Board of Zoning Adjustment for the District of Columbia

Pre-Hearing Statement of ANC1C for BZA 19115

This pre-hearing statement is filed by ANC1C as an appeal of the Zoning Administrator's (ZA) decision to issue building permit B1509180 (Exhibit 3) on June 24, 2015. ANC1C contends that the ZA erred in defining that the lower level at 1636 Argonne Place, NW as a cellar, based upon an incorrect determination of the "adjacent finished grade" (AFG) for the rear and front of the building.

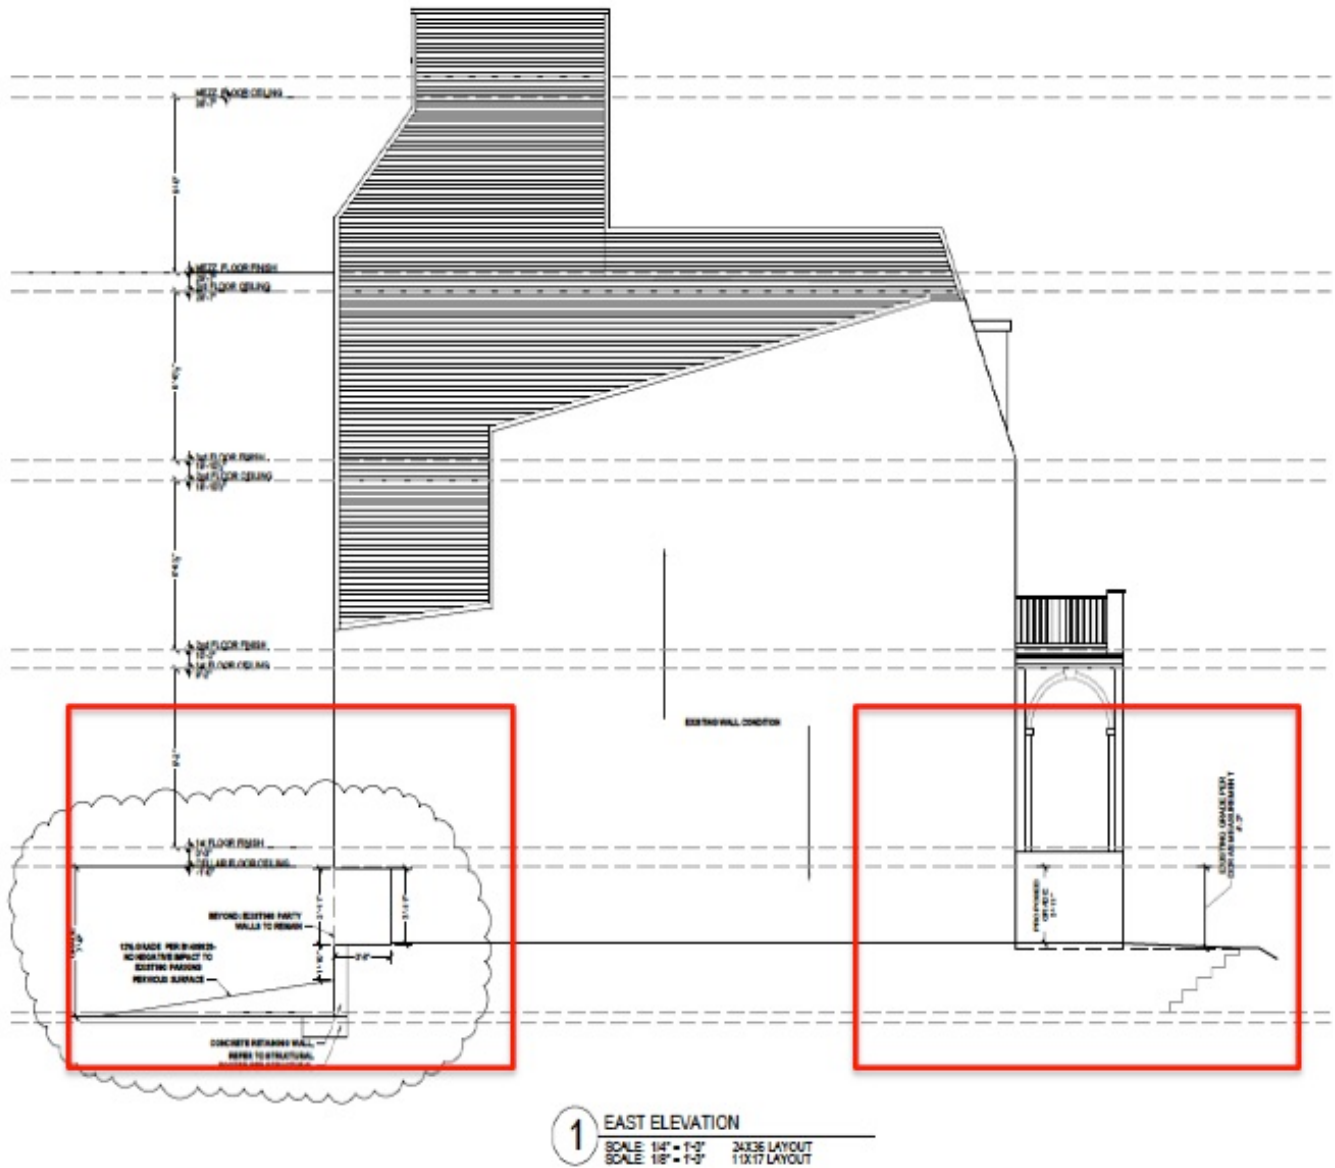
Misidentification of AFG: Rear of Building. The rear AFG is 7'6".

Misidentification of AFG: Front of Building. The front AFG is misrepresented on construction drawings dated June 4, 2015 as follows (see next page):

- At the entryway, construction plans dated June 4, 2015 state the front grade as "GRADE 3'11." This is inaccurate as the actual conditions at the site show an entryway with a closed gate and an AFG of ~8'. (Note: This entryway is the proper AFG as it is not an "areaway," which is excluded from AFG.)
- At the sidewalk outside of the entryway, construction plans dated June 4, 2015 identify the front grade as "EXISTING GRADE PER DCRA'S MEASUREMENT 4'2" (basement perimeter, see below).

B1509180 – Rear Grade

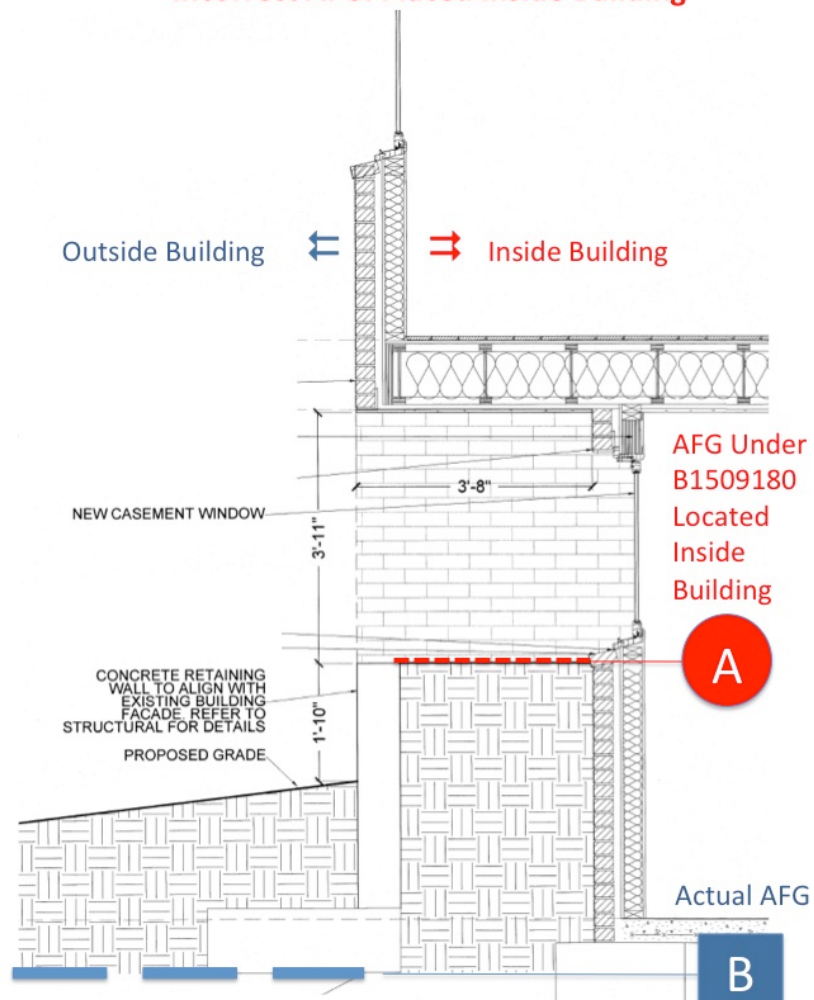
Incorrect
Rear Grade

Incorrect AFG: Placed Inside Building

B1509180 – Front Grade

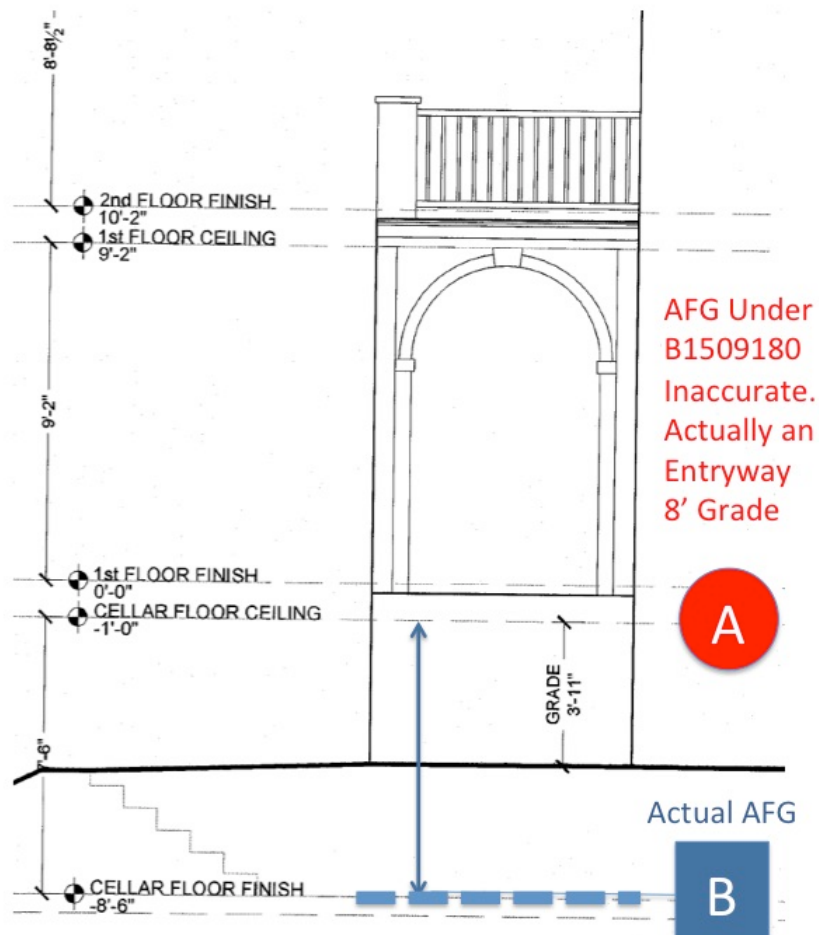
Incorrect
Front Grade

Incorrect AFG: Placed Inside Entryway, Which is ~8' AFG
